Service Bulletin

Bulletin No.: 21-NA-048

Subject: Black Screen in Reverse with Red Triangle and Red Camera with A Circle and Slash Through It

Preliminary Service Procedure

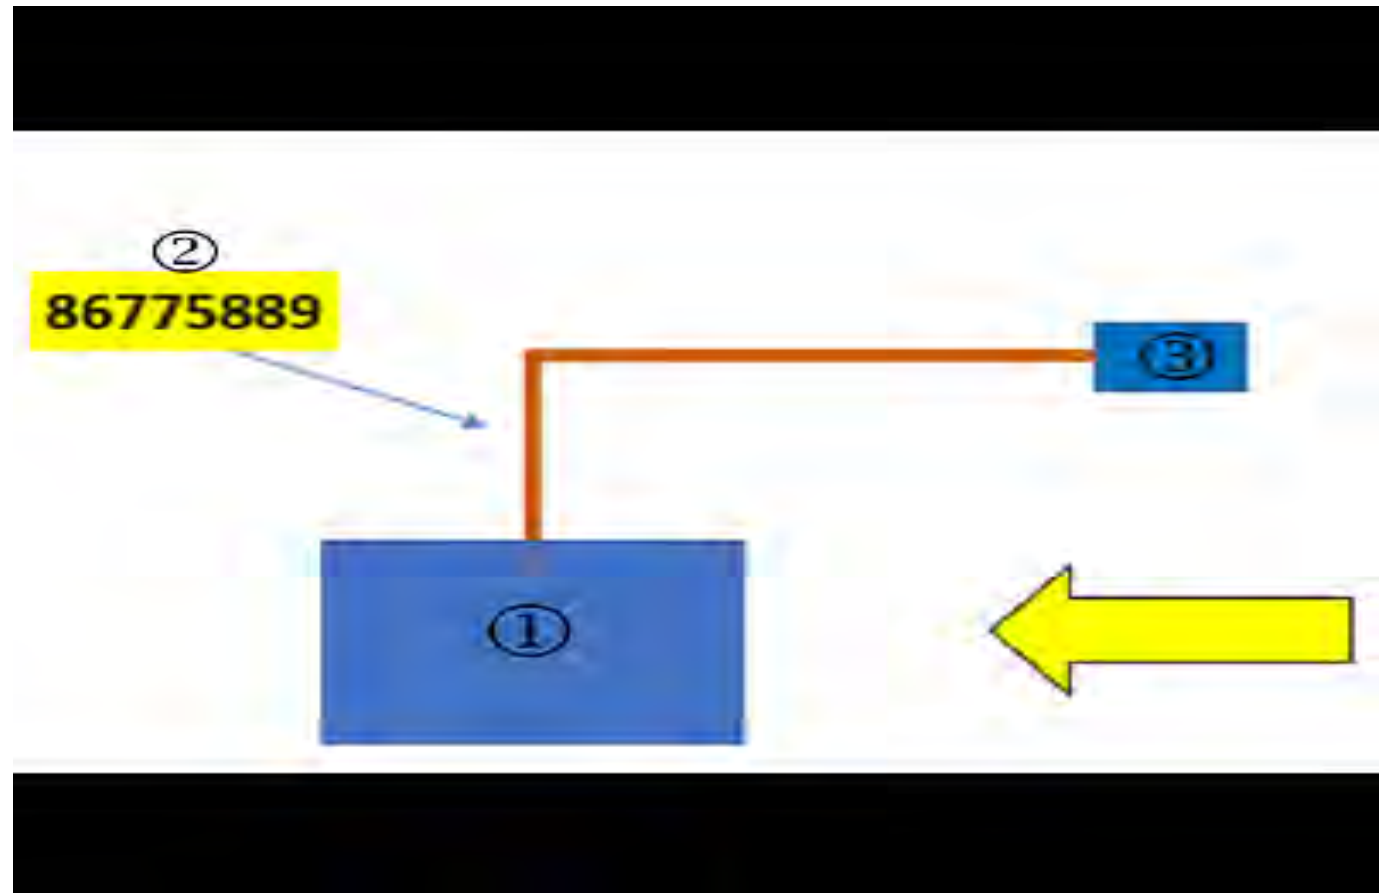
1. Verify that the A11 Radio header is not loose.
 - 1.1. To do this, gain access to the IP coaxial cable behind the right kick panel.
 - 1.2. Hold the cable an inch or two below the connection to the A11 Radio and while watching the screen in Reverse, gently move the cable back and forth.
 - 1.3. If you get pink lines on the screen or if it goes black, replace the A11 Radio. Refer to the appropriate *Radio Replacement*, in SI.
2. Continue to coaxial replacement as shown by model below.

2020-2021 XT5 IP and Body Coaxial Cable Routing (DRZ & UV2)

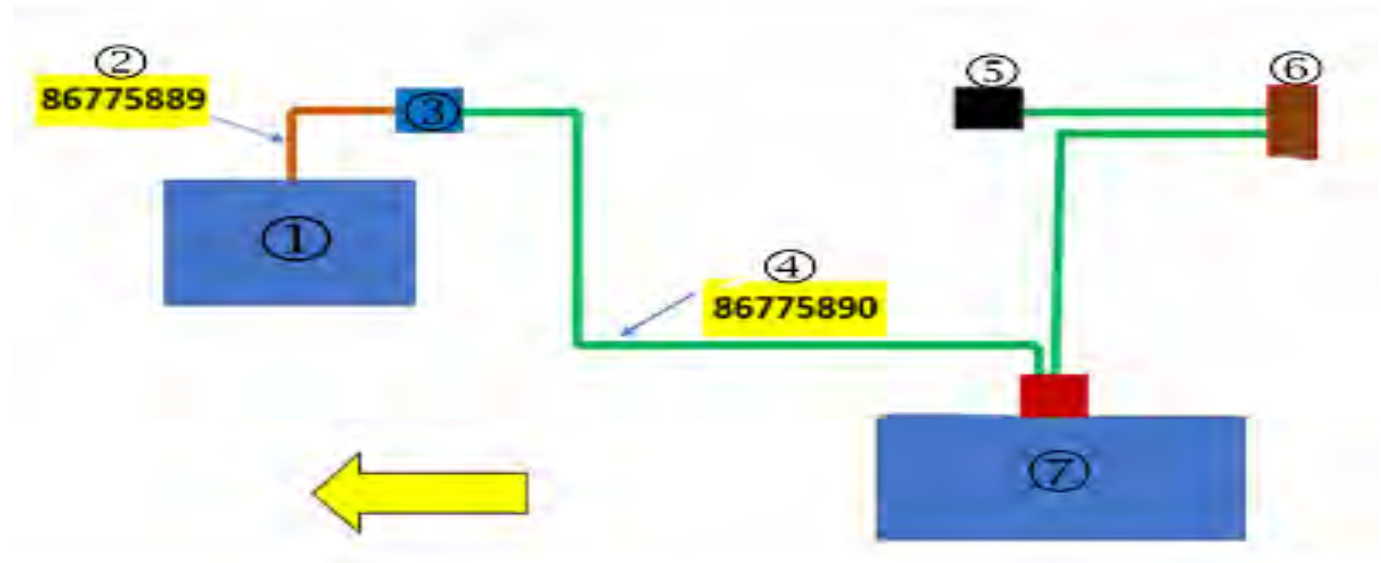
Note: The long cable will be an overlay routed with, and affixed to, the body harness. The original body coax will just need the ends off and can be abandoned in the main body wiring harness.

Note: On XT5, the (Body) cable runs from the VPM to the In-line connection to the (IP) short cable behind the right kick panel. It also routes to the liftgate coaxial connector and to the coax at the top of the left "D" pillar headliner area for the rearview mirror.

1. Replace the long Coaxial cable (Body) from the VPM in the left rear of the vehicle, to the In-line connection to the (IP) short cable behind the right kick panel and to the liftgate connector and connect to the cable to the rearview mirror in the top left "D" pillar headliner area.
2. Replace the short (IP) coaxial cable from the in-line connection to the A11 Radio, located behind the right kick panel.

Acadia
 2020-2021 Acadia IP and Body Coaxial Cable
 Routing (UV2)

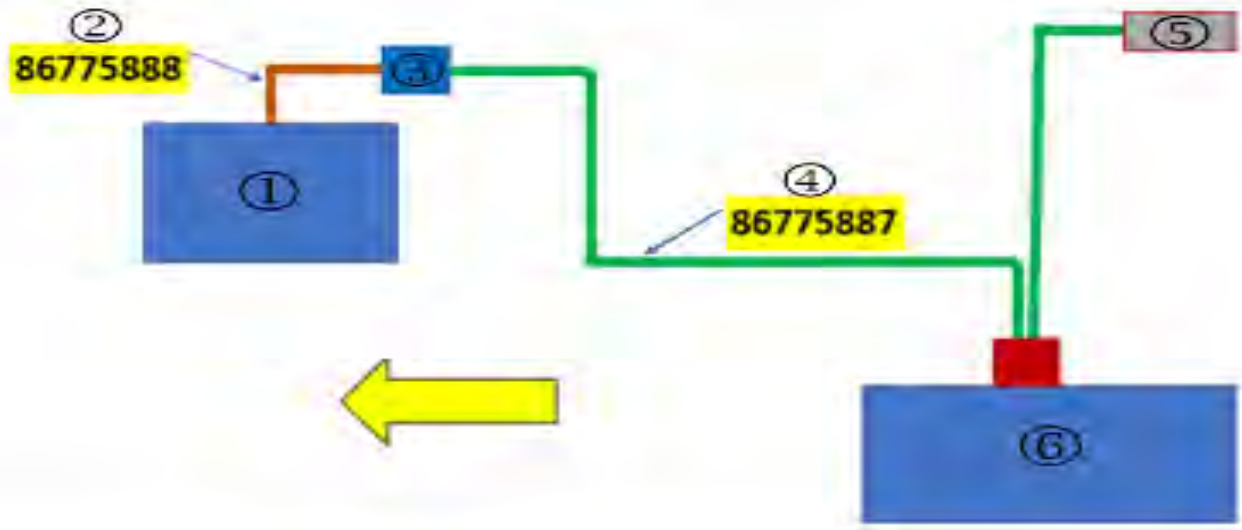
Note: The long cable will be an overlay routed with, and affixed to, the body harness. The original body coax will just need the ends off and can be abandoned in the main body wiring harness.

Note: On Acadia, the (Body) cable runs from the VPM to the In-line connection to the (IP) short cable behind the right kick panel and to the liftgate coaxial cable connector.

- 1. Replace the long Coaxial cable (Body) from the VPM in the left rear of the vehicle, to the In-line connection to the (IP) short cable behind the right kick panel and to the liftgate coaxial cable connector.
- 2. Replace the short (IP) coaxial cable from the in-line connection to the A11 Radio, located behind the right kick panel.
